# E99-24

IBC: 1024.3; IFC: [BE] 1024.3

**Proponents:** Jeffrey Grove, Coffman Engineers, Coffman Engineers (jeff.grove@coffman.com)

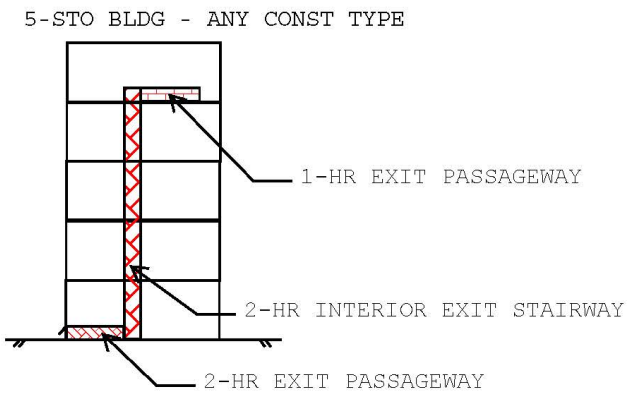
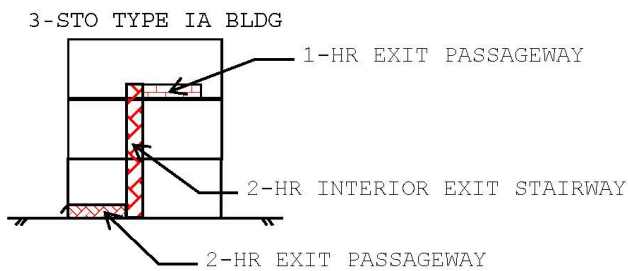
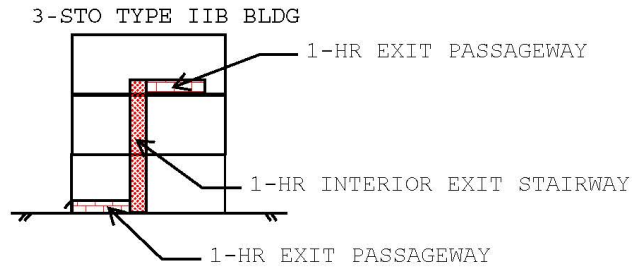
**Reason:** It is clearly the intent of the Code that an exit passageway, whether required for travel distance or some other reason, may be of minimum one-hour fire-resistance rating, regardless of the type of construction or number of stories in a building. There are many times that this is misinterpreted that if you are located in a Type I building, or several stories up in a structure, that the exit passageway must be two-hour rated.

This is a similar proposal as E98-21 which was Approved as Submitted during the Public Comment Hearings, but was ultimately disapproved during the OGCV. To further clarify the intention of this proposal, exhibit schematics have been included with this submission. These examples illustrate this language as follows:

- One-story Type IA building - an exit passageway is required to be a minimum of 1-hour fire-resistance construction, regardless that the building has a required structural fire-resistance greater than 1-hour.

- Three-story Type IIB building - the exit passageway on Level 3 is required to be a minimum of 1-hour fire-resistance construction. The interior exit stairway is required to be of minimum 1-hour fire-resistance construction, and any exit passageways that extend from the stairway are to be of minimum 1-hour fire-resistance construction.

- Three-story Type IA building - the exit passageway on Level 3 is required to be a minimum of 1-hour fire-resistance construction. The interior exit stairway is required to be of minimum 2-hour fire-resistance construction (due to the penetrated 2-hour floor assemblies), and any exit passageways that extend from the stairway are to be of minimum 2-hour fire-resistance construction.

- Five-story building of any construction type - the exit passageway on Level 5 is required to be a minimum of 1-hour fire-resistance construction. The interior exit stairway is required to be of minimum 2-hour fire-resistance construction, and any exit passageways that extend from the stairway are to be of minimum 2-hour fire-resistance construction.

*Exit passageway* enclosures shall have walls, floors and ceilings of not less than a 1-hour *fire-resistance rating*. The fire-resistance rating of an exit passageway, where extending from an interior exit stairway or ramp, shall not be less than that required for the , and not less than that required for any connecting interior exit stairway or ramp. Exit passageways shall be constructed as *fire barriers* in accordance with Section 707 or *horizontal assemblies* constructed in accordance with Section 711, or both.
